# Access Compliance Report

## Public Rights-of-Way

### (Curb Ramps)

Intersection ID: 3030	Main Street: AMBER_GLEN_DR	Cross Street: JASPAR_CREST_LN	Location:	N
ADA ID: 29592C019650	Ramp Type: Perp	Initial Pass/Fail: Fail	Overall Compliance: No	Severity Score: 8.75
Codes/Mitigation Info/Possible Solution		Field Measurements/Component Compliance

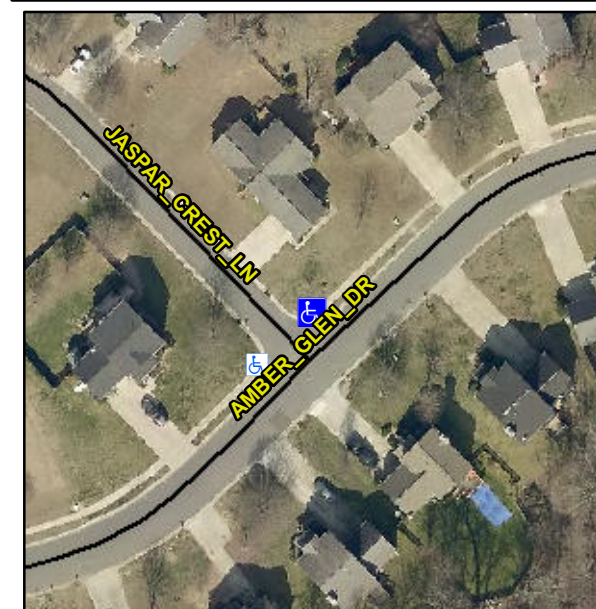
**Not Found, R304.5.1**

Compliance	Description	Data	Compliance	Description	Data
N/A	Ramp Length (in)	44.0	Yes	Ramp Slope (%)	5.7
No	Ramp Width (in)	46.0	Yes	Ramp XSlope (%)	0.0
N/A	Flare Type LT	N/A	N/A	Flare Type RT	N/A
N/A	Flare Slope LT (%)	N/A	N/A	Flare Slope RT (%)	N/A
N/A	Flare Traversable LT?	N/A	N/A	Flare Traversable RT?	N/A
N/A	Landing Length (in)	N/A	N/A	DWS Provided?	N/A
N/A	Landing Width (in)	N/A	N/A	DWS Contrast?	N/A
N/A	Landing Slope (%)	N/A	N/A	DWS Length (in)	N/A
N/A	Landing X Slope (%)	N/A	N/A	DWS Full Width?	N/A
N/A	Landing Curb? (Y/N)	N/A	N/A	DWS Offset (in)	N/A
N/A	Shared Landing?	N/A			
N/A	Gutter Ponding?	N/A	N/A	Gutter Slope (%)	N/A
N/A	Gutter Lip Ht (in)	N/A	N/A	Gutter X Slope (%)	N/A
N/A	Painted X Walk1?	No	N/A	Painted X Walk2?	N/A
	X Walk 1 Direction	To SW		X Walk 2 Direction	N/A
N/A	X Walk 1 Width (in)	N/A	N/A	X Walk 2 Width (in)	N/A
	X Walk 1 Slope (%)	1.4		X Walk 2 Slope (%)	N/A
	X Walk 1 X Slope (%)	1.7		X Walk 2 X Slope (%)	N/A

N/A	Ramp inside XWalk1?	N/A	N/A	Ramp inside XWalk2?	N/A
	Road Slope (%)	N/A	N/A	Clear Space?	N/A
	Road X Slope (%)	N/A	N/A	Clear Space to XWalk (in)	N/A
N/A	Any Obstructions?	N/A	N/A	Storm Grate/Utility Hazard?	N/A
	Obstruction Type			Storm Grate/Utility Type	
		N/A			N/A
			Yes	Surface Condition? (G/P)	Good

**Remove & Replace Entire Ramp.**
